GROUNDWATER SUSTAINABILITY AGENCY
FOR THE WESTERN MANAGEMENT AREA
IN THE SANTA YNEZ RIVER GROUNDWATER BASIN

STAFF MEMORANDUM

SUBJECT: Recommended Response to SWRCB Staff Comments on the Santa Ynez GSPs' Characterization of Santa Ynez River Alluvium Above the Narrows

**RE: SANTA YNEZ VALLEY GROUNDWATER SUSTAINABILITY PLANS,
GROUNDWATER BASIN NO. 3-015**

FIGURE 2

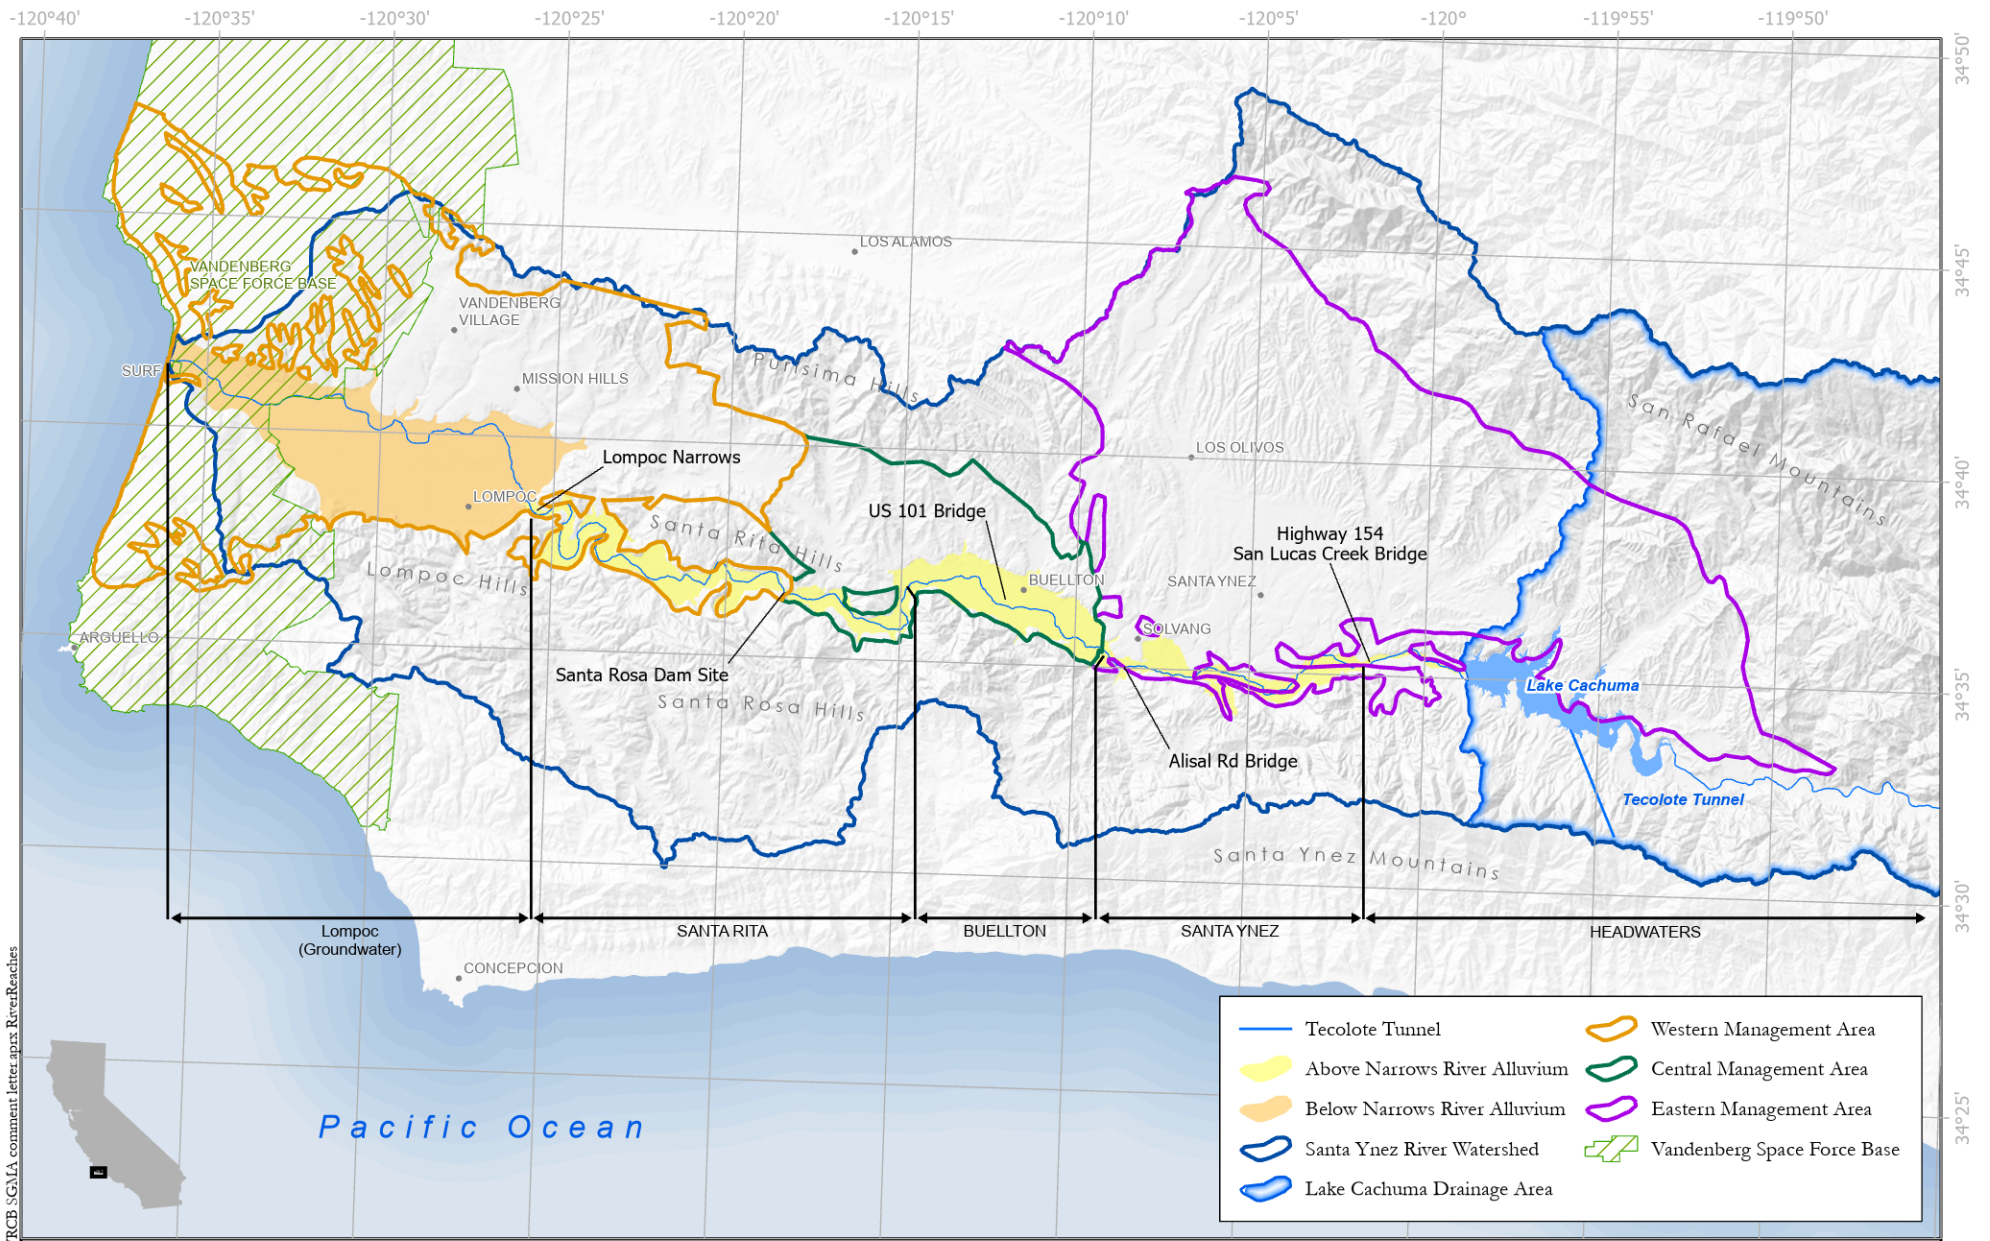
The April 2023 SWRCB Staff Comments were addressed to all three GSPs' management areas, so the entire lower Santa Ynez River is shown in **Table 1** and **Figure 2**. The underflow channel is one subterranean

^B The April 2023 SWRCB Staff Comments only discuss where “alluvial deposits are underlain by both the Paso Robles Formation and the Careaga Sandstone [...]” The Paso Robles Formation is not extensively present under the alluvium. Where both the Paso Robles Formation and the Careaga Sandstone are present describes only a small portion of the Buellton Reach entirely within the CMA. Upstream of the Lompoc Narrows, the Buellton Reach described above is inclusive of all areas where either formation is present.

FIGURE 3

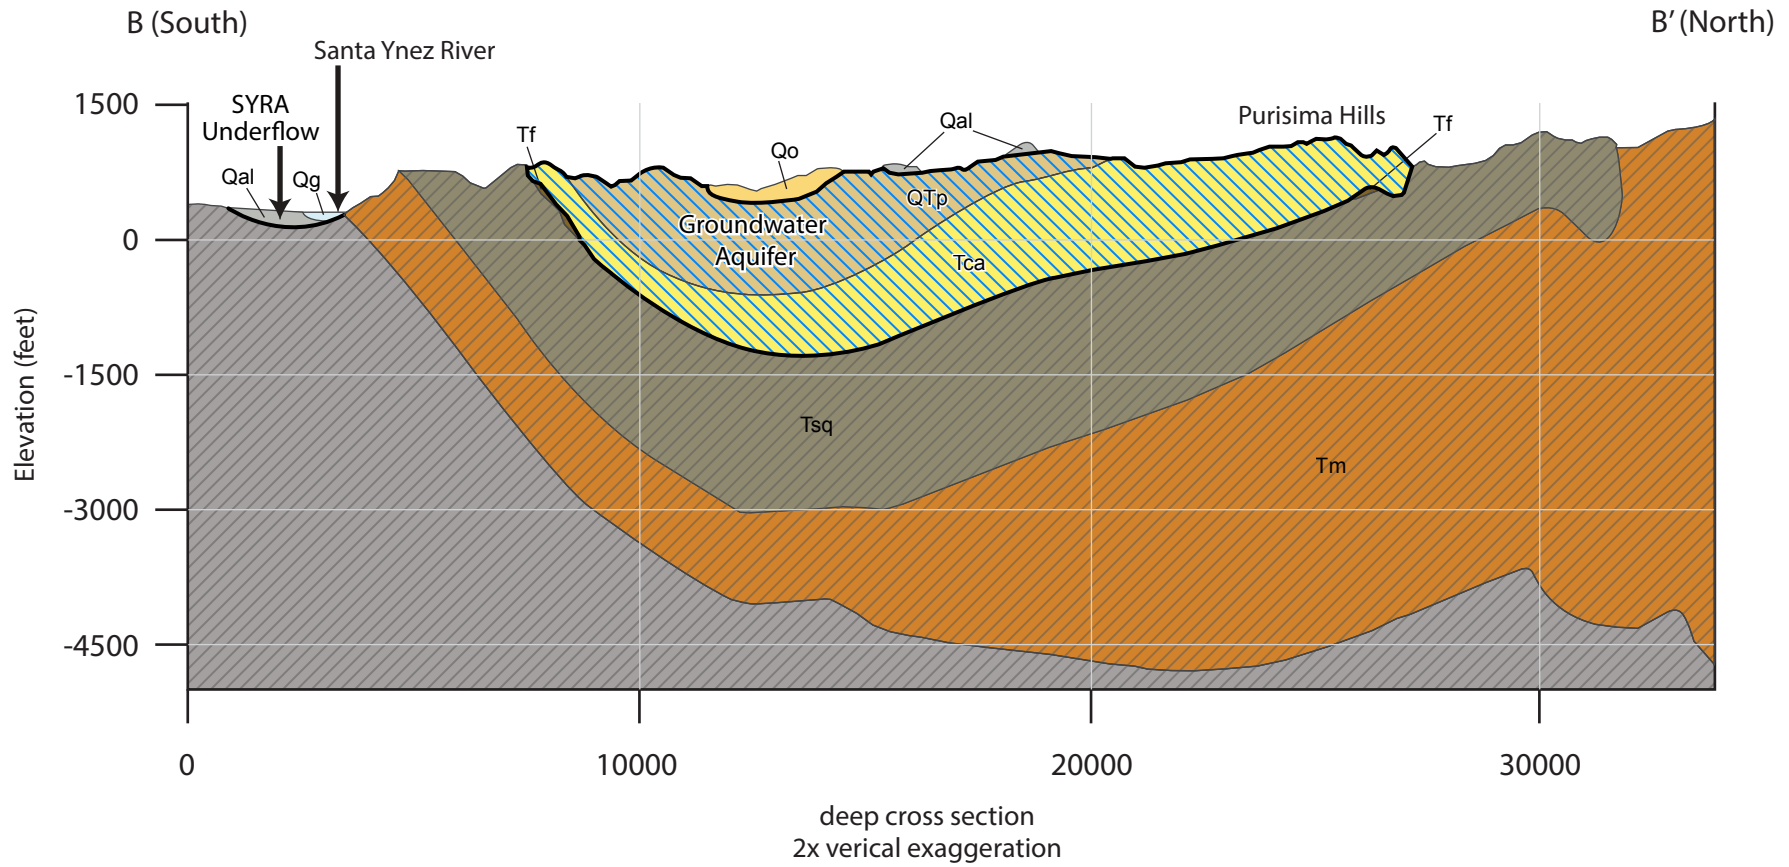
Approximately 29 of the 36 river miles above the Lompoc Narrows are a channel of alluvium bounded on all sides by non-water bearing geological units, with no direct interface with the groundwater aquifer (e.g., **Figure 3**). In most places, the Monterey formation is the non-water bearing geologic unit along and underneath the Santa Ynez River. This report's cover photograph shows a typical example of this geological contact. From a technical standpoint, the April 2023 SWRCB Staff Comments focus exclusively on a small area of the Basin where both the Careaga Sandstone and Paso Robles Formation partly underlie the Santa Ynez River. Based on the geological maps (discussed in Section 3.1), this characteristic only occurs within the Buellton Reach of the river (**Table 1** and **Figure 2**). Thus, any suggestion by the Comments that the characteristics of the Buellton Reach apply to any other reach is not supportable.

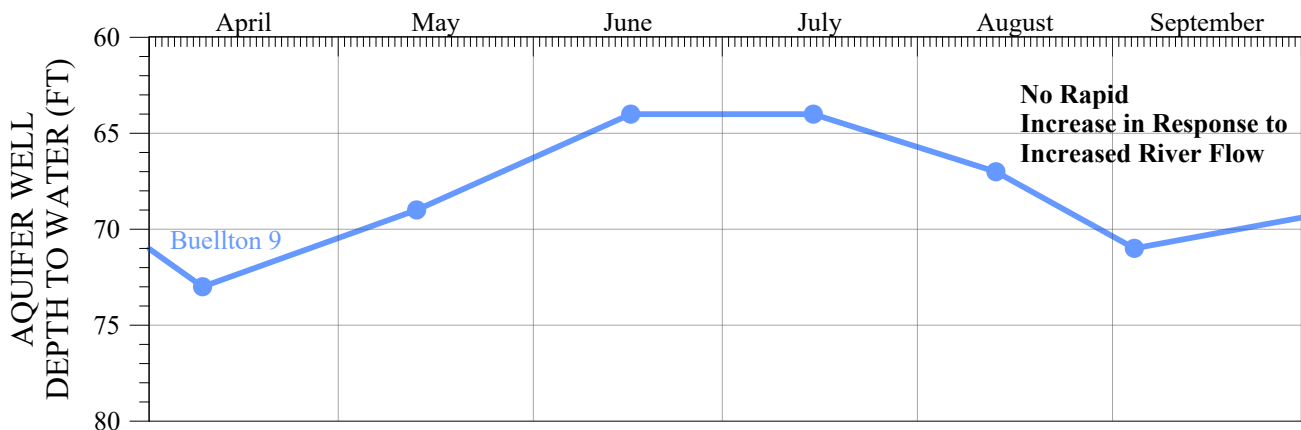
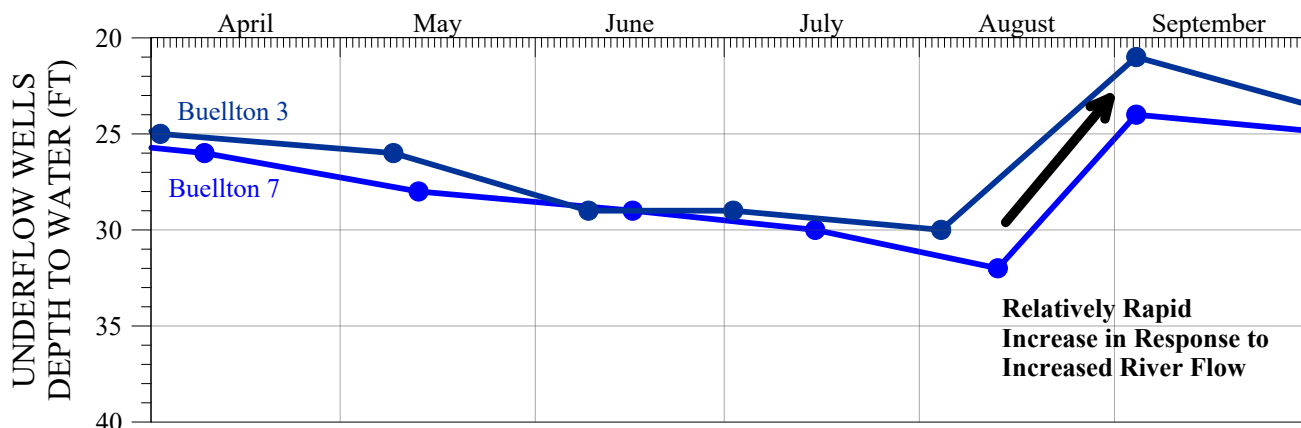
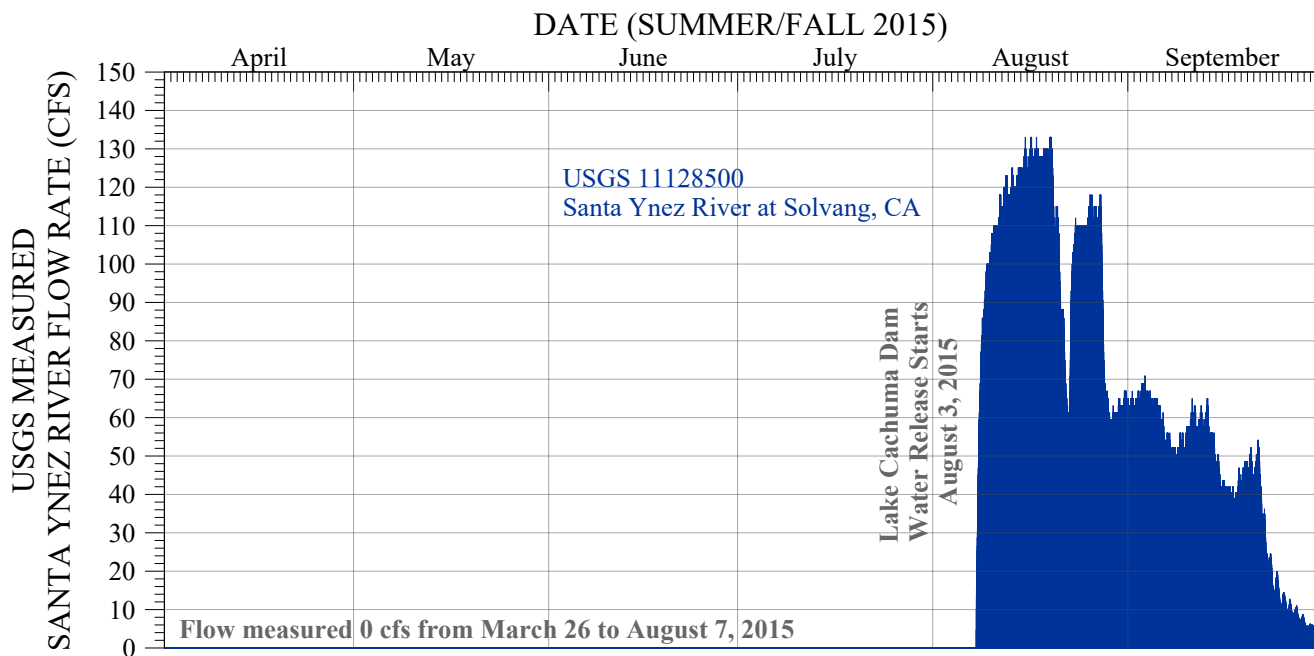
The relative impermeability of the bed and banks is further demonstrated by comparing how the changes in river conditions affect wells screened in the underflow versus a nearby well screened in the Careaga Sandstone and Paso Robles Formation aquifer underlying the alluvium (collectively, the Buellton Aquifer). If there were a similar level of permeability, all wells would respond similarly to the same conditions. **Figure 5** compares three wells in the Buellton reach. The two underflow wells screened in the alluvium show a similar pattern of water levels responding to the surface flow that is not observed in the aquifer well. As shown in **Figure 5**, after release of water from Lake Cachuma, the two wells in the underflow in the Buellton reach show a rapid response and increase in water level, but this does not occur in the well screened in the underlying groundwater aquifer. This indicates that the bed and banks in the Buellton Reach are relatively impermeable, which is the same area questioned in the SWRCB Staff Comments.

FIGURE 6
GEOLOGICAL CROSS-SECTION FROM THE EMA GEOLOGICAL MODEL
(EXCERPT, EMA GSP FIGURE 4-3)

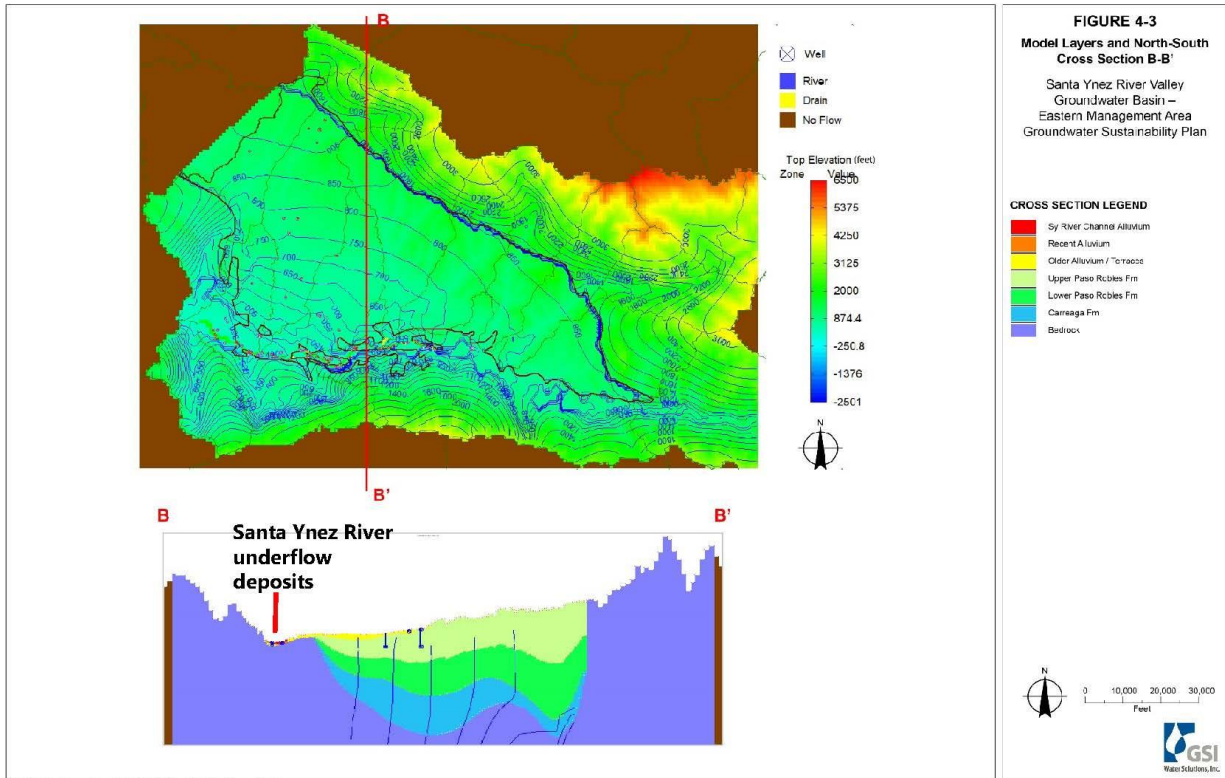
This effort resulted in developing a complete three-dimensional model of the entire area included in the DWR boundaries of the groundwater basin and the immediate surroundings. From this model, any number of cross-sections of the geology can be drawn, including the areas along the Santa Ynez River. **Figure 6** is an example cross-section from the EMA that shows the predominant relationship of the Santa Ynez River, younger alluvium, and the regional groundwater aquifers of the Careaga Sandstone and Paso Robles Formation in this location (described as the Santa Ynez reach in the earlier Section 1). As the example of Figure 6 shows, the younger alluvial deposits are within a well-constrained “known and definite” channel.
